**RESPONSES TO THE NUCLEAR REGULATORY
COMMISSION MAY 20, 2004, REQUEST FOR ADDITIONAL
INFORMATION REGARDING THE ENVIRONMENTAL
MONITORING PROGRAM PLAN**

**U.S. Department of Army
Installation Support Management Agency
Aberdeen Proving Ground, Maryland**

**Science Applications International Corporation
Reston, Virginia**

November 2004

Figure 1-1. DU Wells Within and Surrounding the DU Impact Area

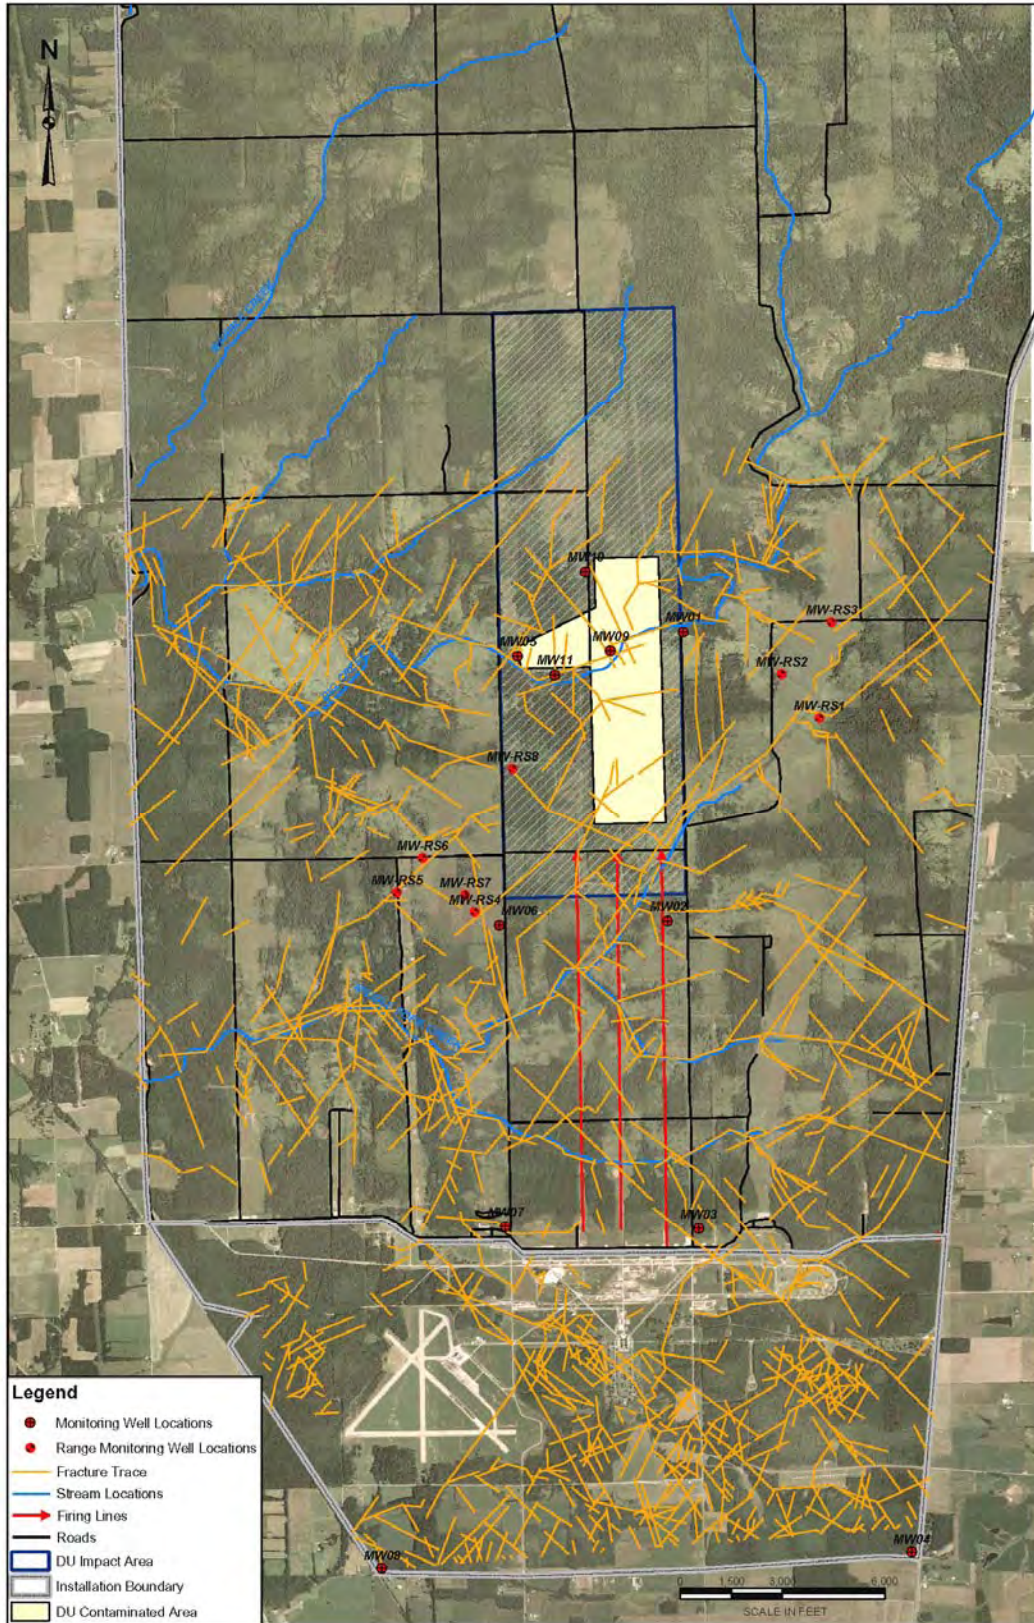
The Army should provide additional information on the conceptualized site model that was originally used to locate the sampling points for groundwater, surface water and stream sediments. The conceptual model of the hydrologic system for the DU Impact Area should include all potential water-bearing units, surface water systems, caves, springs, and the unsaturated zone that may be impacted by the degradation and movement of the DU penetrators. The Army should provide information on the interrelationship between DU concentrations in the groundwater, surface water, caves, springs and stream sediments.

fracture trace analysis (Greeman 1981) documented numerous fractures and lineaments present within the DU Impact Area (see **Figure 1-1**).

Numerous types of karst features were observed to be present on JPG and within the DU Impact Area. Several caves along Big Creek within the DU Impact Area and along downstream sections of Big Creek were identified. All three of the caves identified within the DU Impact Area along Big Creek were noted as having springs discharging at their entrances. There are two caves that were identified along the Middle Fork Creek. Neither cave is located within the DU Impact Area, but one is located approximately 1,000 ft to the west of the westernmost 2000-meter (m) target location and is noted to have a stream discharging from the cave into Middle Fork Creek. Based on the location of this cave, some of the groundwater contribution of this stream could originate in the DU Impact Area.

Regionally, the bedrock groundwater flow direction is toward the west to southwest. The presence of the observed karst features and mapped fracture traces/lineaments indicates that solution-enlarged discontinuities are present in the bedrock. These features act as preferential flow pathways within the bedrock aquifer and will control and dramatically affect groundwater flow volume and direction and, therefore, contaminant transport. The shallow bedrock aquifer could receive recharge from the surface water and unconsolidated aquifer (sinkholes, caves, jointing within the till, and losing stream sections) in addition to potentially discharging to the surface water (springs, streams from caves, and gaining stream sections). Either or both of these conditions, recharge to or discharge from the shallow bedrock aquifer, could be occurring depending on the position within the individual groundwater basins and the local conditions.
